Addendum #1

Attn: Estimator	Date: November 14, 2024
From: Lisa Donahue, Project Administrator	Pages: 58 (including cover page)
Re: Bullock Creek School District 2024 Bond Series 1	Project: 2025 Summer Projects HS/MS/Elem/Pine River/Floyd and Maintenance Building
CC:	Proj. #: A24907

Project: No. 24-120 2023 Bond – Series 1 2025 Improvements

Issue Date: November 14, 2024

SEAL	DRAWN	PROJECT NO.
	KRS	24-120
	CHECKED	CAD FILE NO.
	JESS	A-A102
	REVIEWED	DRAWING NO.
	MLB	A-A102
	DATE	SHEET NO.
	OCT 18, 2024	3 OF 12
	SCALE	
	AS NOTED

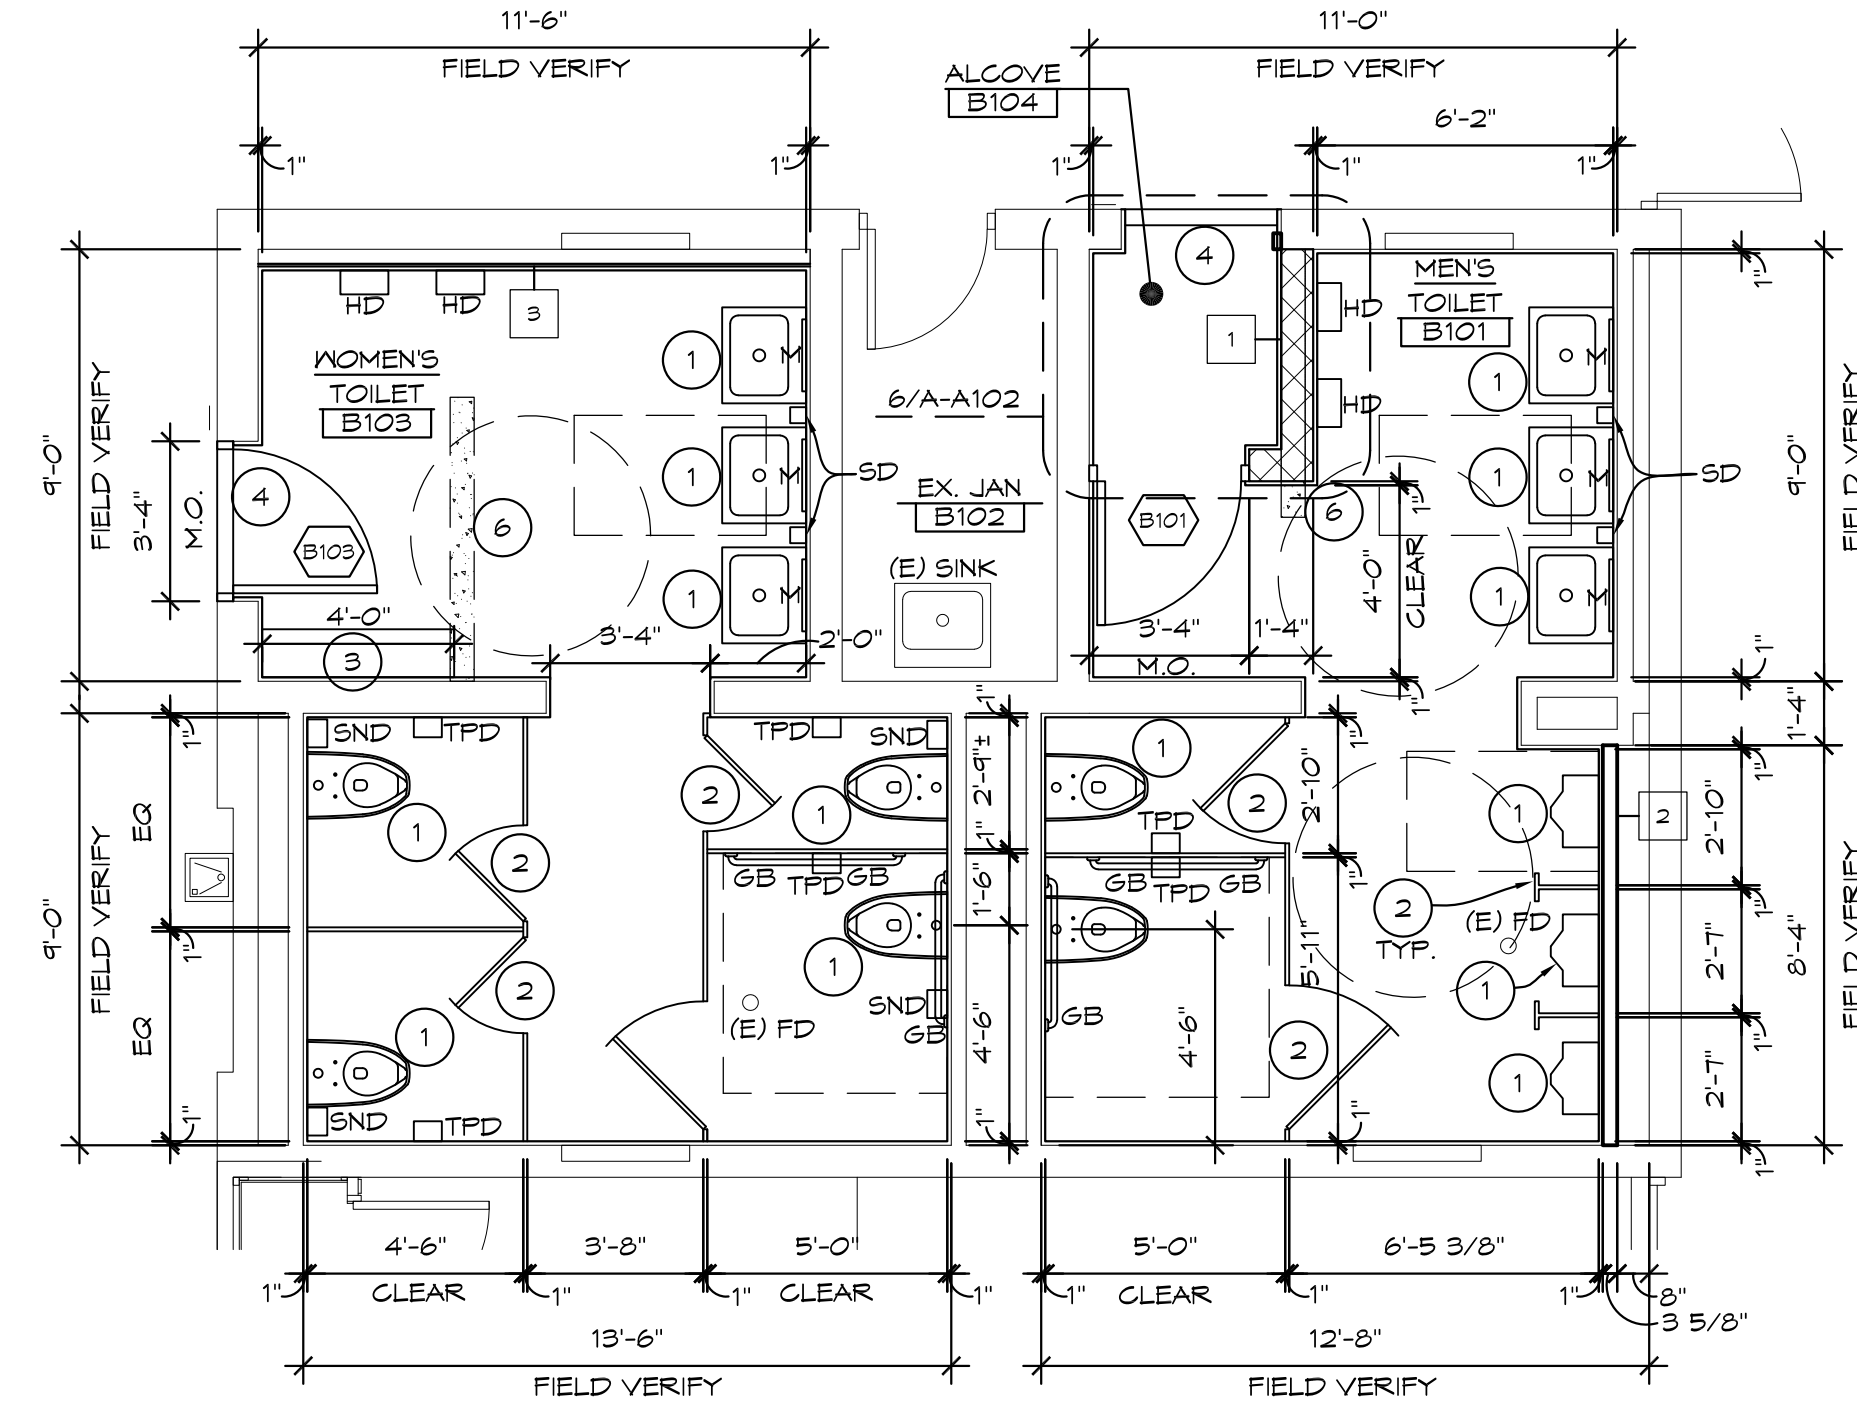
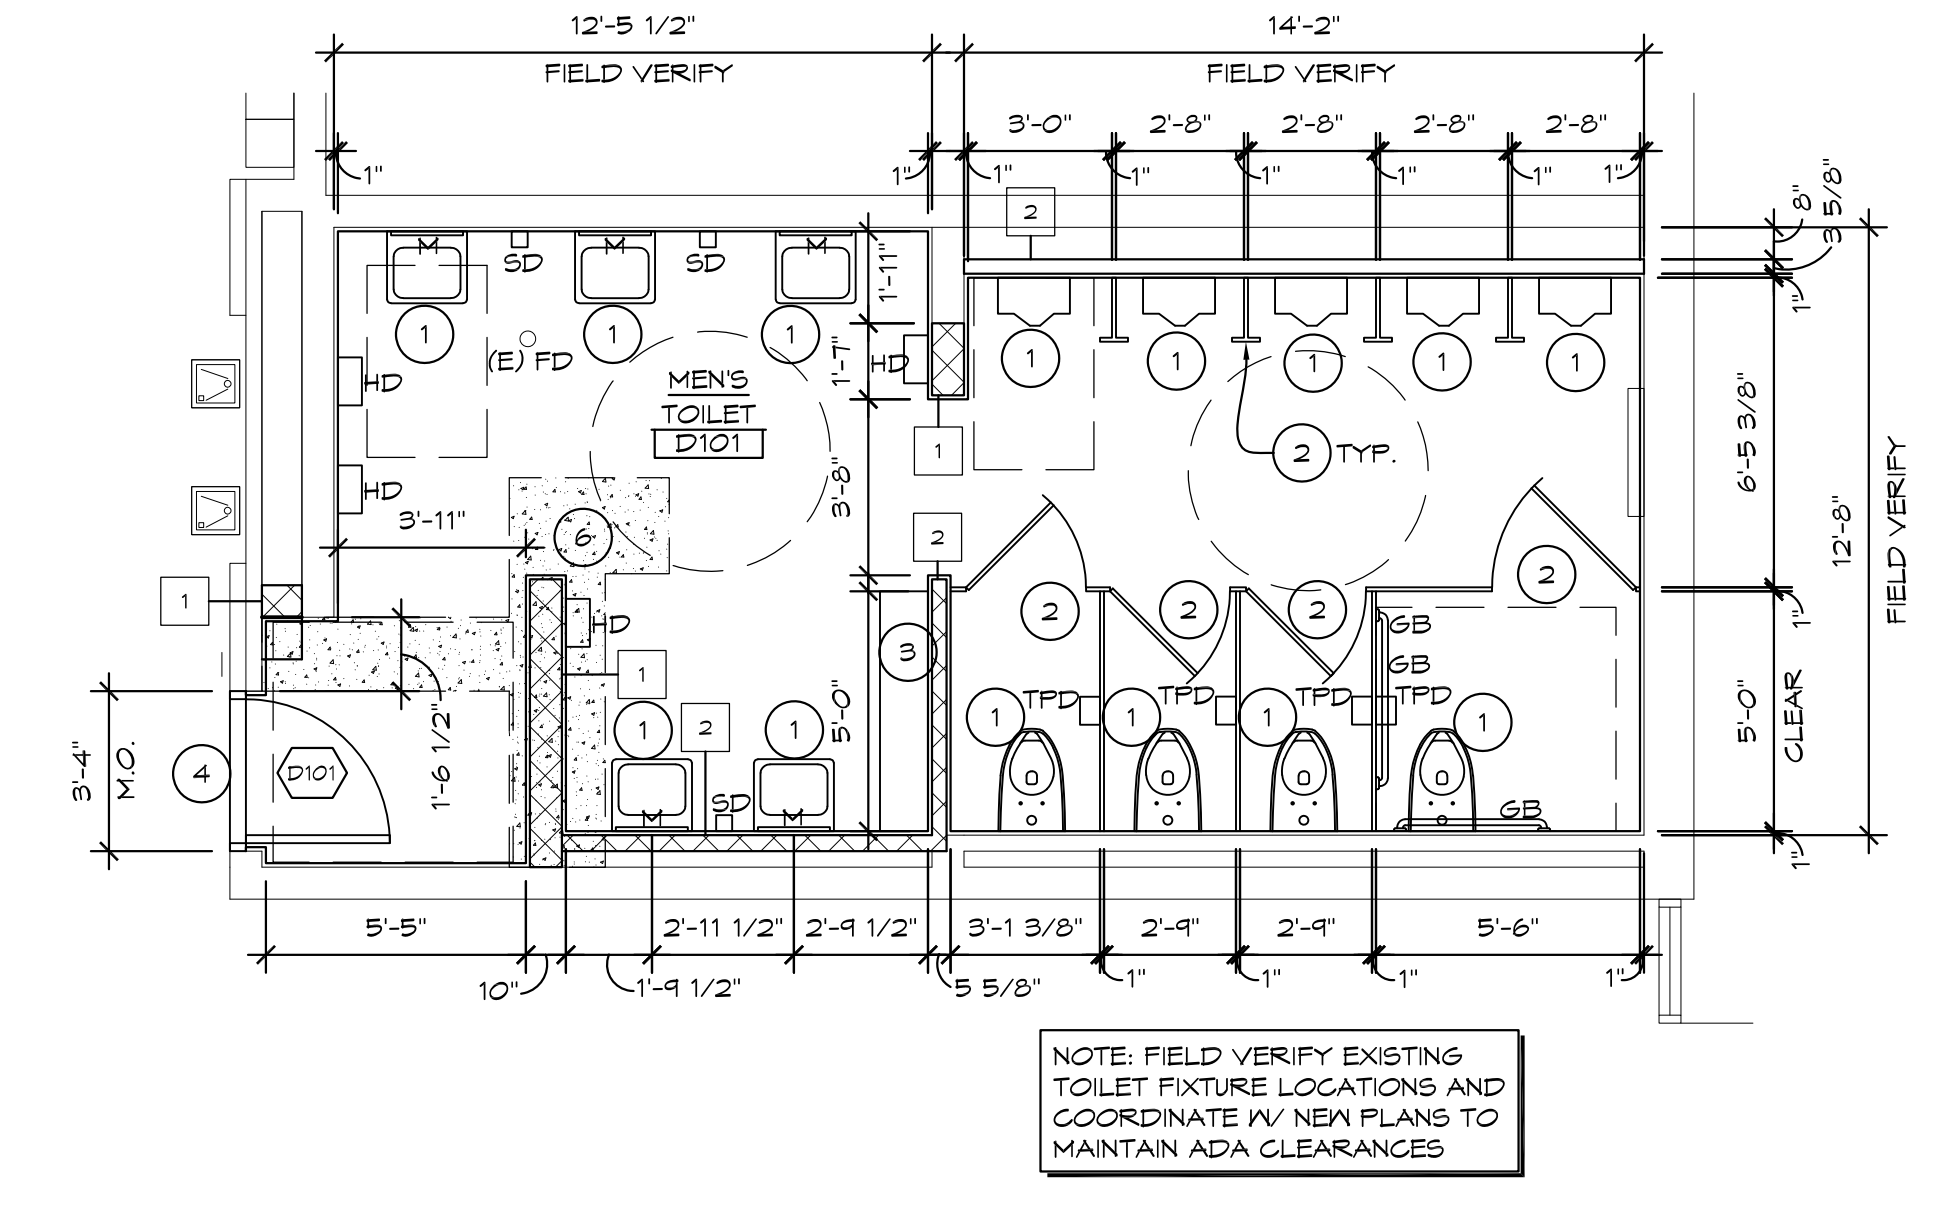
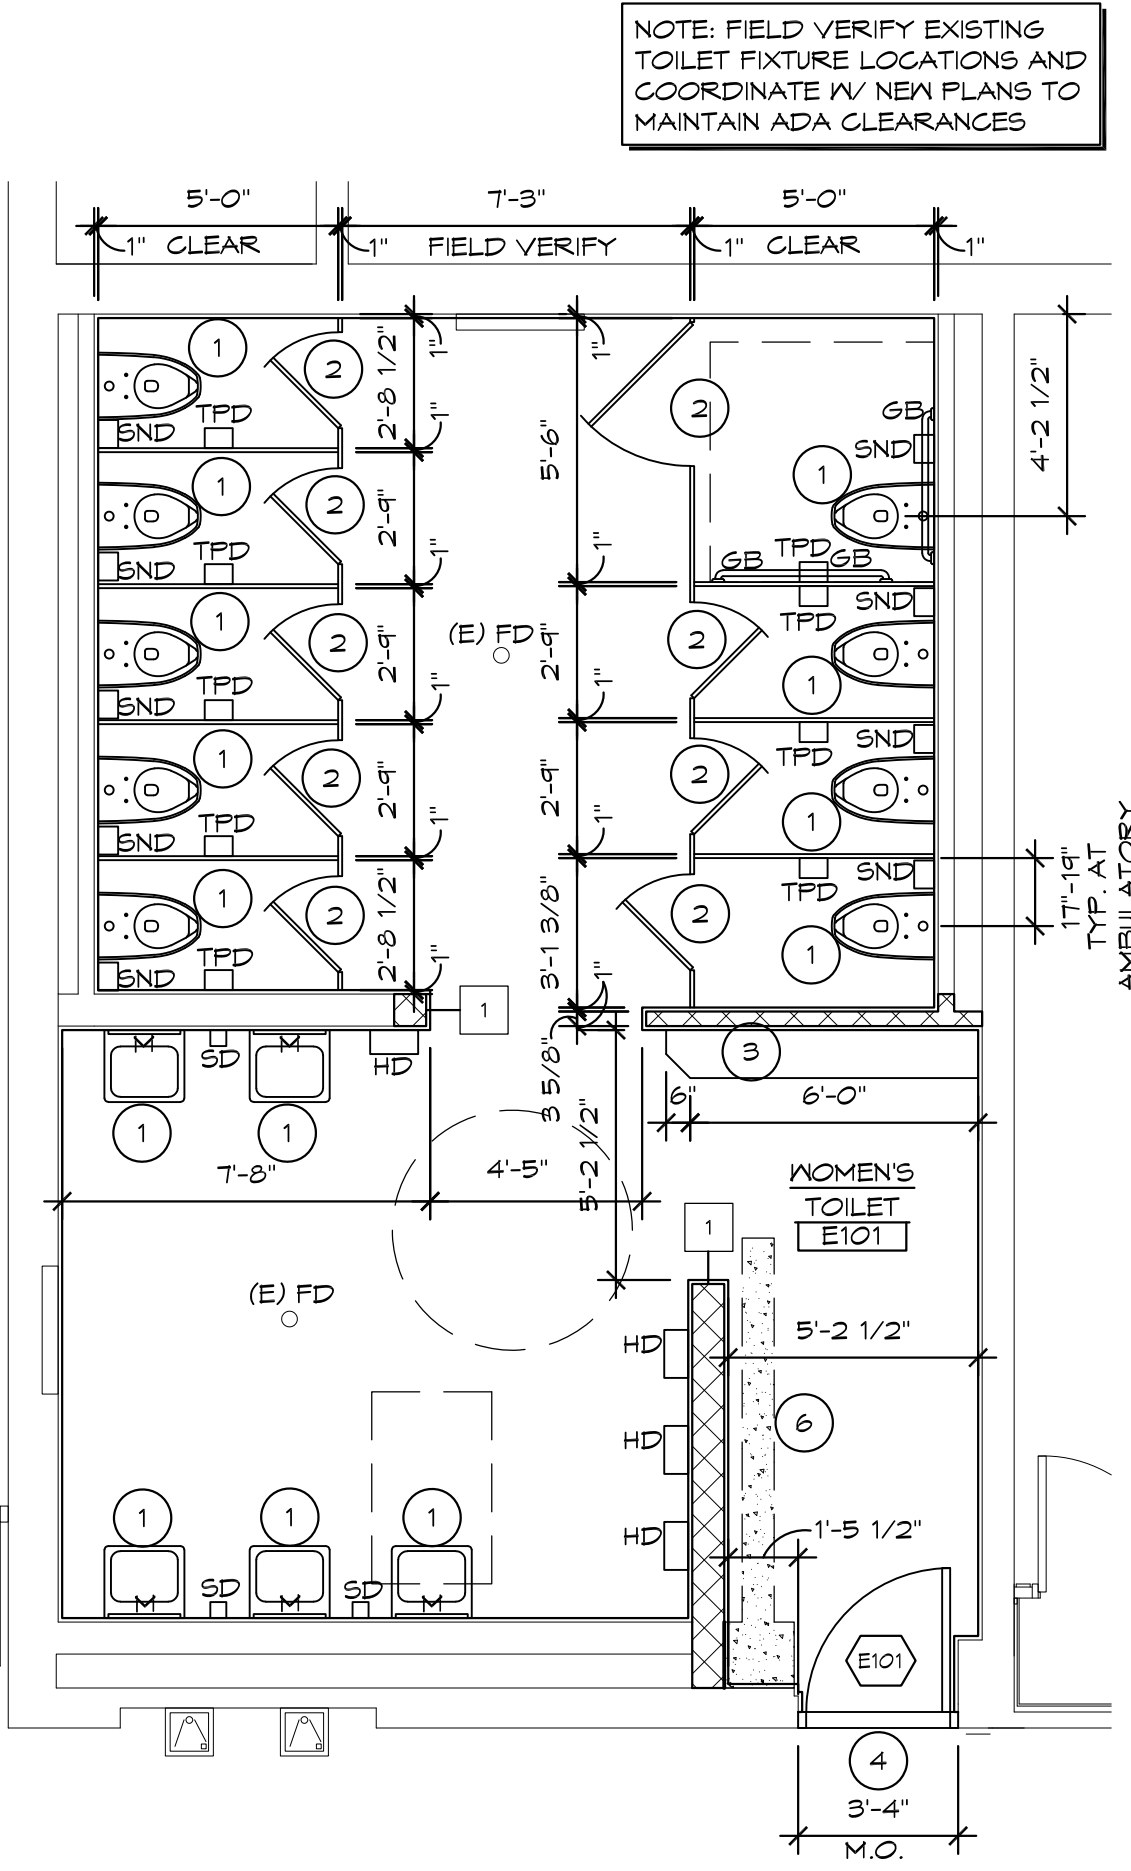
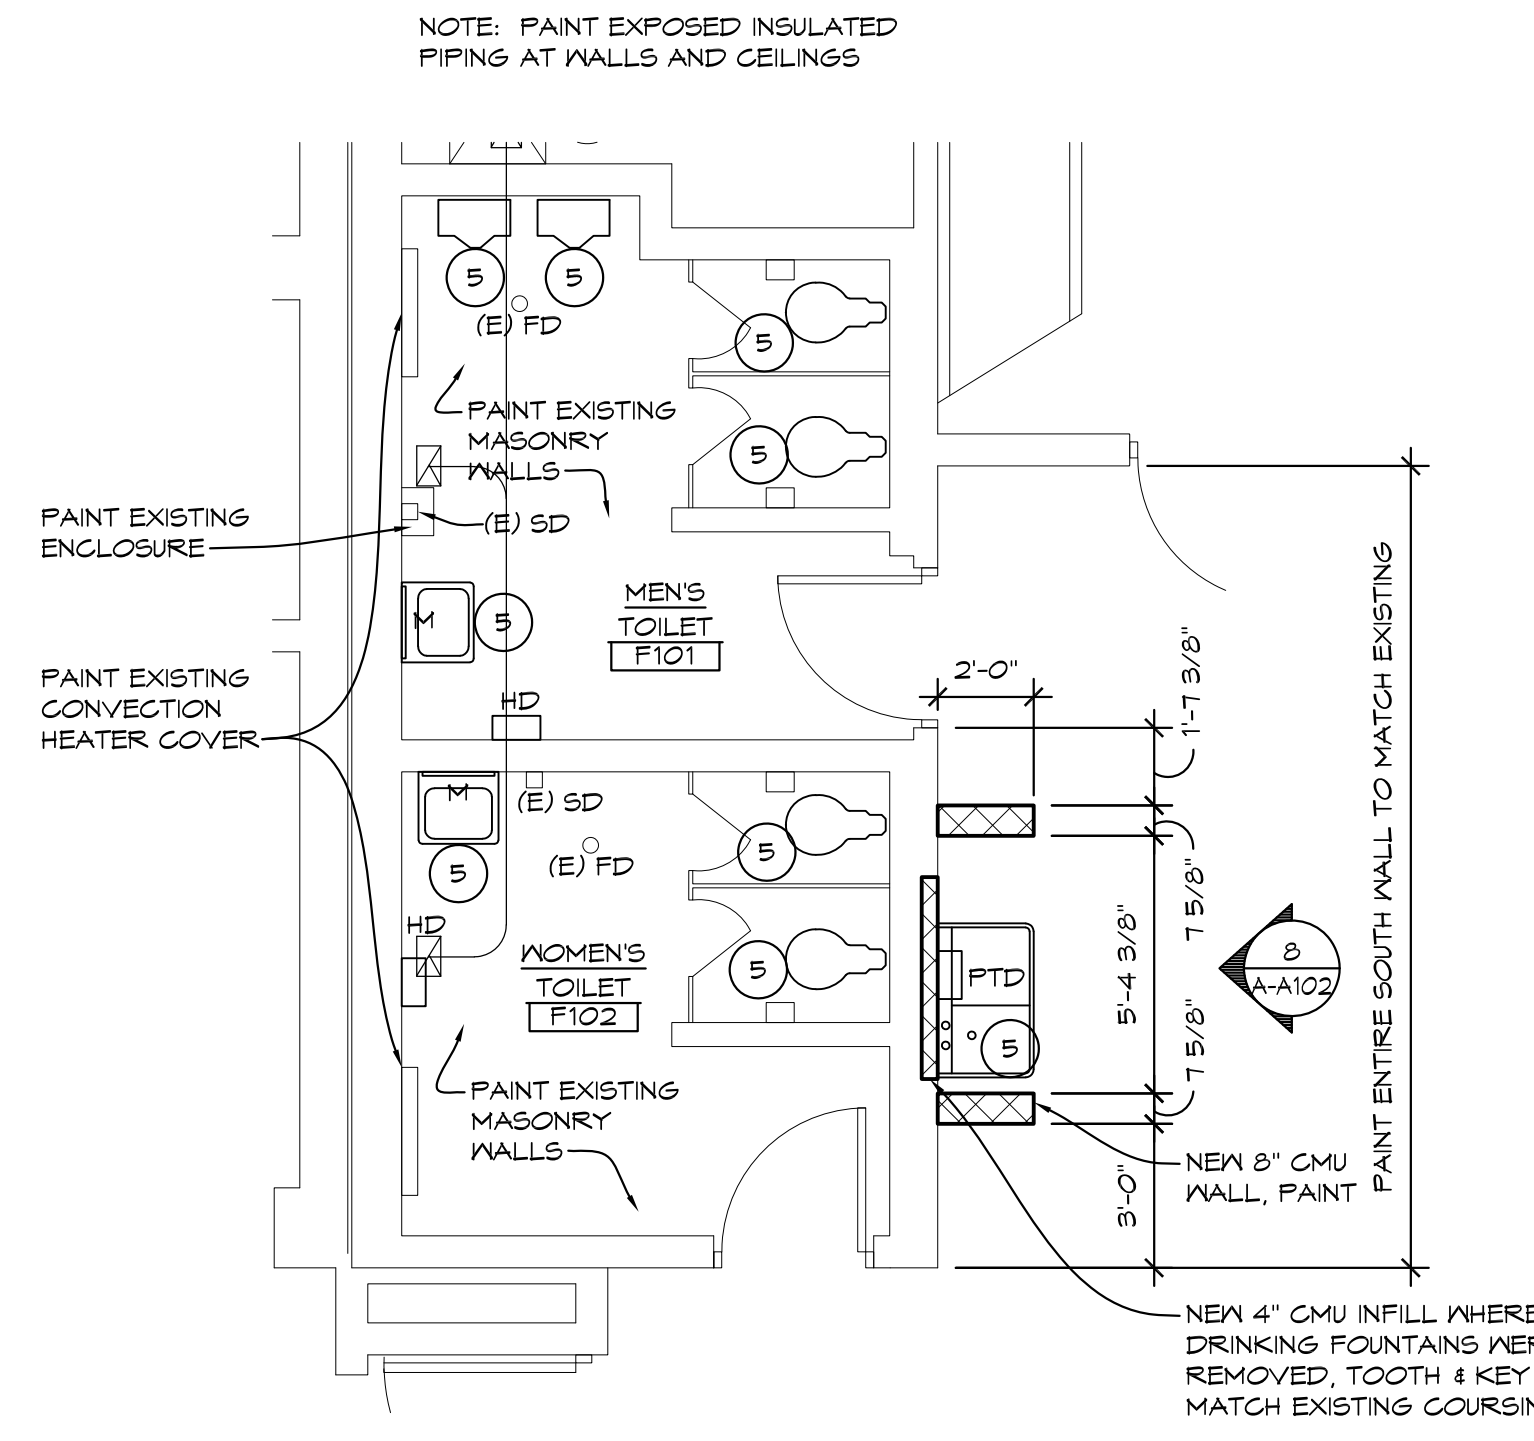
- Item #A1: Revise Sheet A-G001 as follows:
- a. Updated index of drawings and sheet count.
- Item #A2: Revise Sheet A-A101 as follows:
- a. Updated sheet count.
- Item #A3: Revise Sheet A-A102 as follows:
- a. Updated sheet count.
- Item #A4: Revise Sheet A-A103 as follows:
- a. Updated sheet count.
 - b. Detail 5 revised to show existing bulkheads.
 - c. Detail 6 revised to show updated bulkhead detail.
- Item #A5: Revise Sheet A-A601 as follows:
- a. Updated sheet count.
 - b. Details 1 and 2 revised to show updated head and jamb details.
